Rezoning Transportation Analysis

Petition Number: 2019-115

Date	Description
09-29-2019	First Review
11-15-19	Second Review
1-9-2020	Third Review

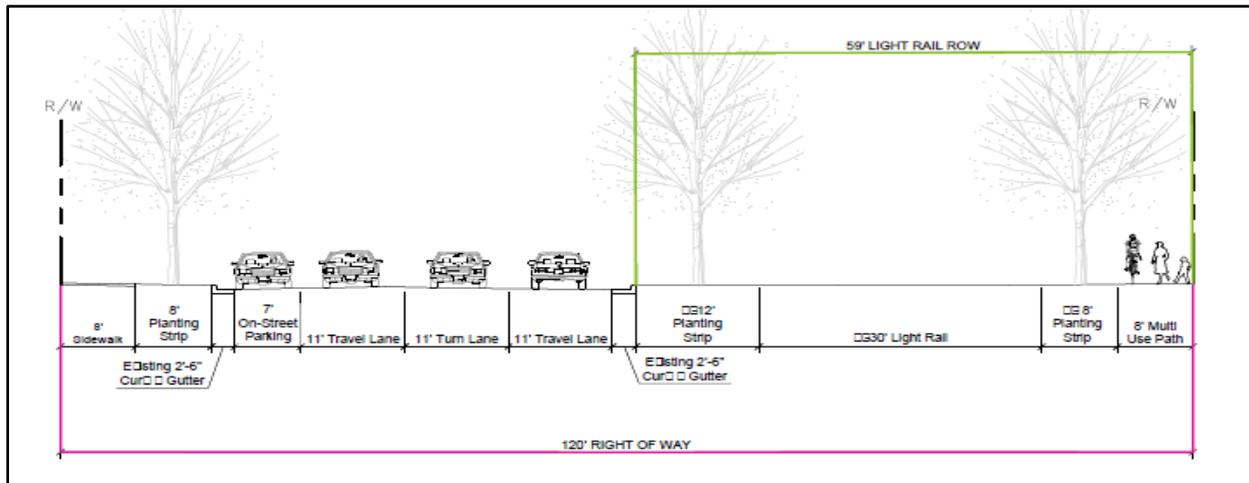
4. The petitioner should revise conditional note III. d. "Phase III Development & Major Transportation Event" and Major Transportation Events as referenced under V. Transportation/Roadway Improvements & Implementation stating a *Traffic Impact Study* will be provided for Phase III development prior to the permitting of any portion of Phase III development.

- a. **Updated comment based on revised site plan (12/20/19):** The petitioner should revise the site plan and conditional note "d. Phase III Development & Major Transportation Event" and remove the Major Transportation Event language. The traffic impact study for Phase III should not be combined with a major transportation event.

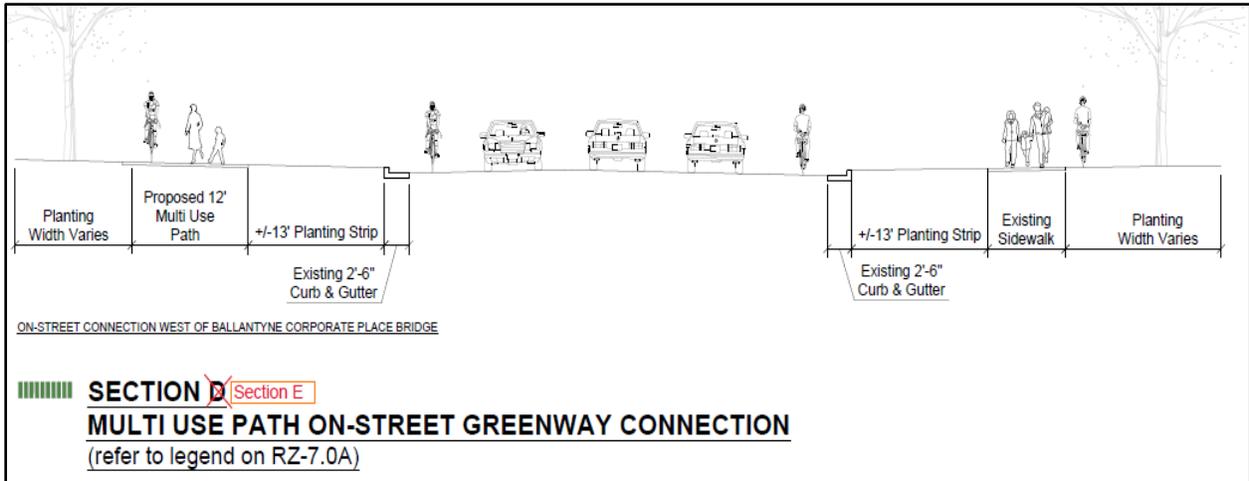
13. ~~Sheet RZ-7.0B shows 2 "Section D" cross-sections and conflict with the street network on Sheet RZ-7.0A. The petitioner should revise the site plan showing the correct matching cross-sections between Sheets RZ-7.0A and RZ-7.0B.~~

~~a. **Comment Clarification Based on Revised Site Plan (10/16/19):** Section D cross-section in Sheet RZ7.0B should be labeled Section "E" to match the site plan in Sheet RZ 7.0A.~~

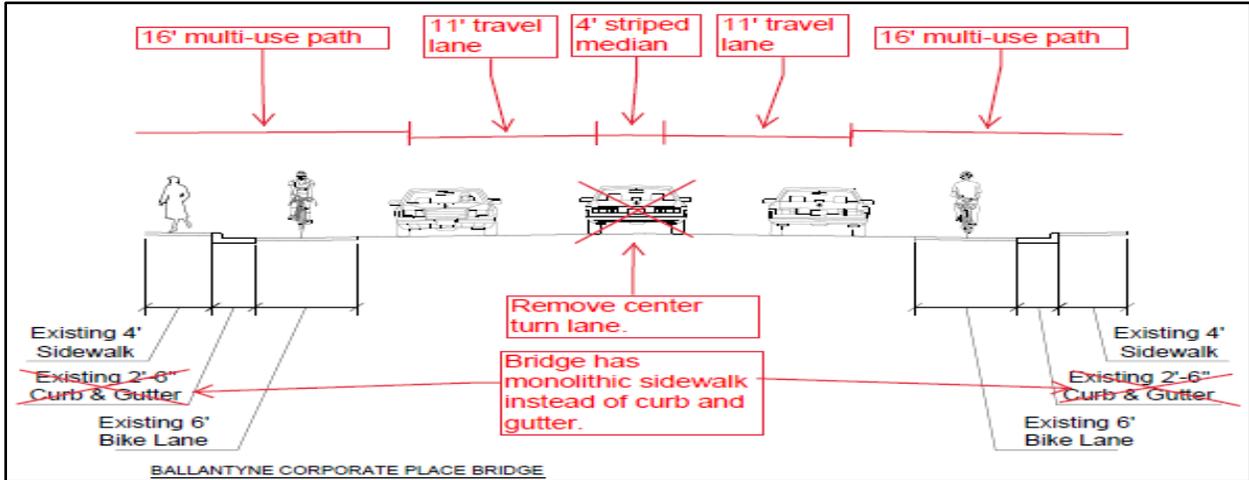
14. The petitioner should revise the site plan and conditional notes to commit to reallocating space on Ballantyne Corporate Place bridge over Johnston Road/521 to be 2 travel lanes, buffered bike lanes, and 8.5' sidewalks.
- a. **Comment Clarification Based on Revised Site Plan (10/16/19):** The Ballantyne Corporate Place bridge cross-section as depicted on RZ-7. OB should be updated to reflect the comments provided below. Furthermore, the total width on the cross-section shown on the rezoning plan does not match the existing width of the bridge. The petitioner should verify the correct width of the bridge is shown accurately on the rezoning plan.
